Re: Florida Power & Light Company
Proposed Turkey Point Units 6 and 7
Docket Nos. 52-040 and 52-041
Response to NRC Request for Additional Information Letter No. 58 (eRAI 6434) -
Concerning Implementation of Fukushima Near-Term Task Force Recommendations

Attachment: FPL Response to NRC RAI No. 01.05-1 (eRAI 6434)

NRC RAI Number: 01.05-1 (eRAI 6434)

Figure 10: CEUS Hard Rock Hazard Results for 100 Hz Spectral Acceleration

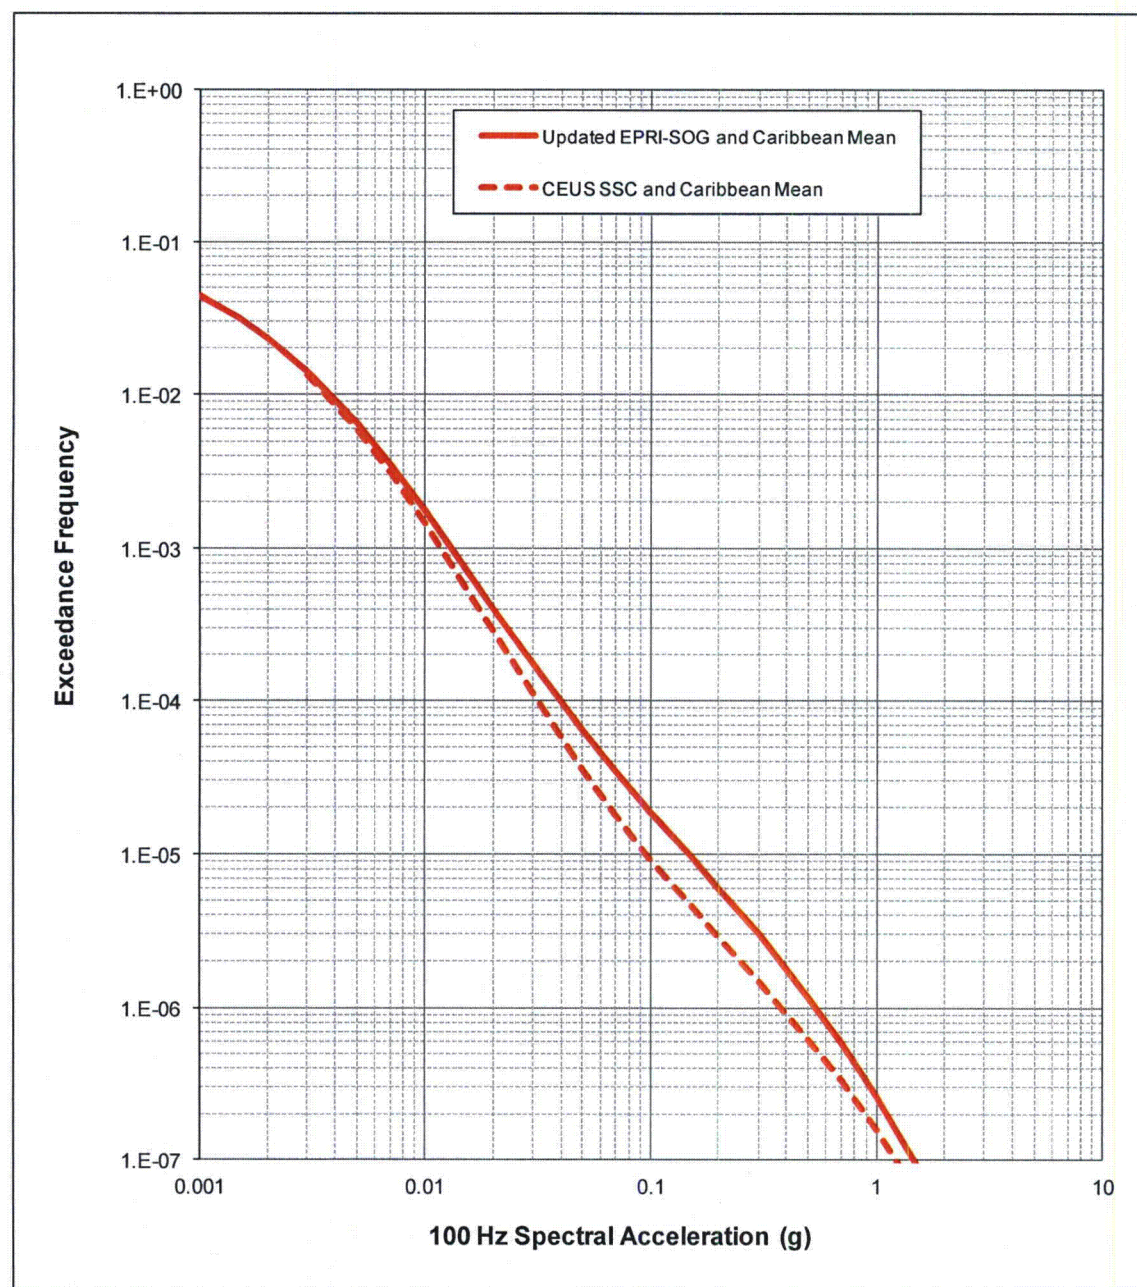
- a) Evaluate the potential impacts of the newly released CEUS SSC model, with potential local and regional refinements as identified in the CEUS SSC model, on the seismic hazard curves and the site-specific ground motion response spectra (GMRS)/foundation input response spectra (FIRS). For re-calculation of the PSHA, please follow either the cumulative absolute velocity (CAV) filter or minimum magnitude specifications outlined in Attachment 1 to Seismic Enclosure 1 of the March 12, 2012 letter "Request for information pursuant to Title 10 of the *Code of Federal Regulations* 50.54(f) regarding Recommendations 2.1, 2.3, and 9.3, of the near-term task force review of insights from the Fukushima Dai-Ichi accident." (ML12053A340).
- b) Modify the site-specific GMRS and FIRS if you determine changes are necessary given the evaluation performed in part a) above.

Figures 4 through 10 compare the total mean hazard from the updated EPRI-SOG plus Caribbean sources presented in Subsection 2.5.2.4 and Table 2.5.2-223 of the FSAR to the total mean hazard from the CEUS SSC model plus Caribbean sources. For structural frequencies of 2.5 Hz and higher, the total hazard computed using the CEUS SSC sources is lower than that computed using the updated EPRI-SOG sources in the important annual exceedance frequency range of $1\text{E-}04$ to $1\text{E-}06$. For structural frequencies of 0.5 and 1 Hz, the total hazard computed using the CEUS SSC model sources is higher by about 3 percent at an exceedance frequency of $1\text{E-}04$ and by about 11 percent at an exceedance frequency of $1\text{E-}06$. These differences in hazard for structural frequencies of 0.5 and 1 Hz are less than the suggested tolerances for hazard accuracy presented in Chapter 9 of NUREG-2115 (Reference 2).
